Response to BAGI Concerns and questions asked at the Committee Hearing

Amendments to Proposal No. 217, 2015

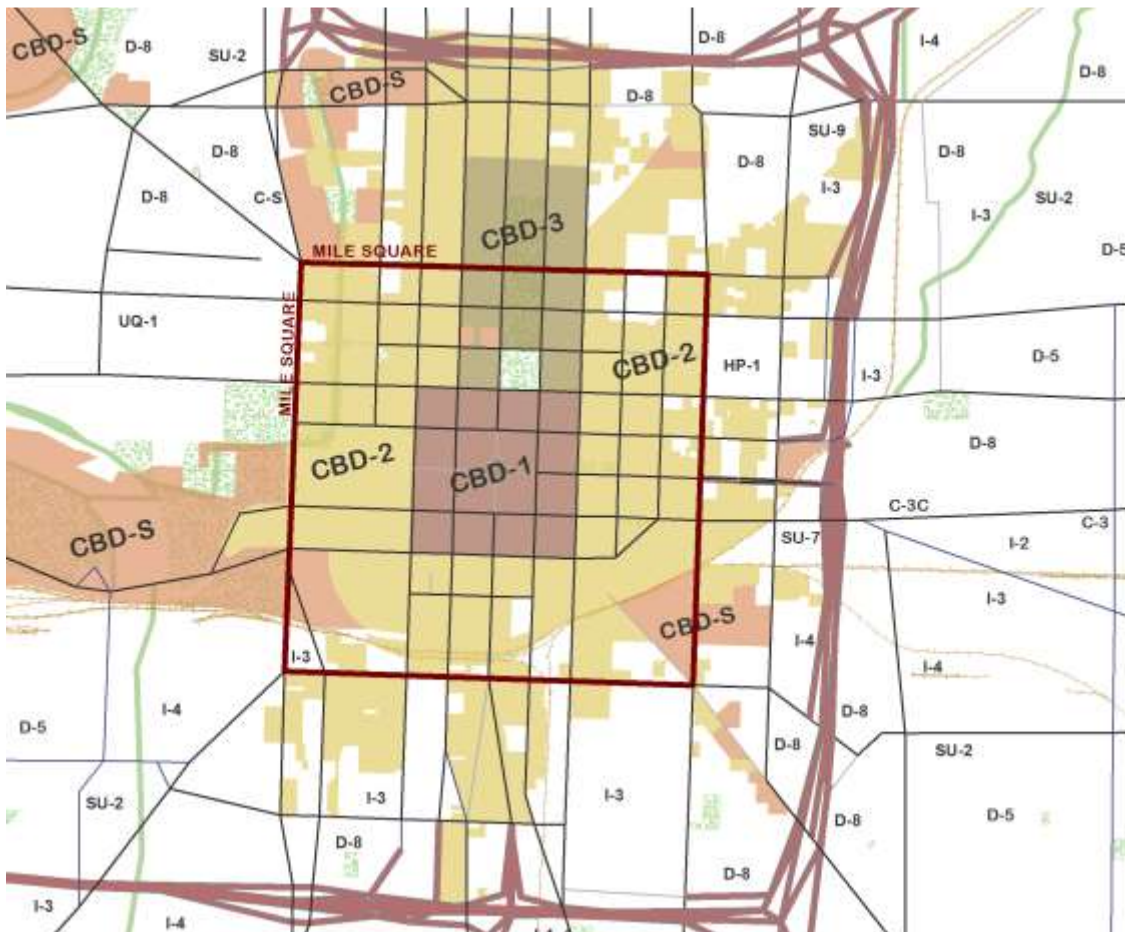
“Are there Parking changes for commercial districts downtown?”

The “downtown” is largely zoned to one of the CBD districts (see map).

In the CBD districts, the parking is regulated by district, while in the other districts parking is regulated by use (or employment). This is the current practice and continues in Indy Rezone.
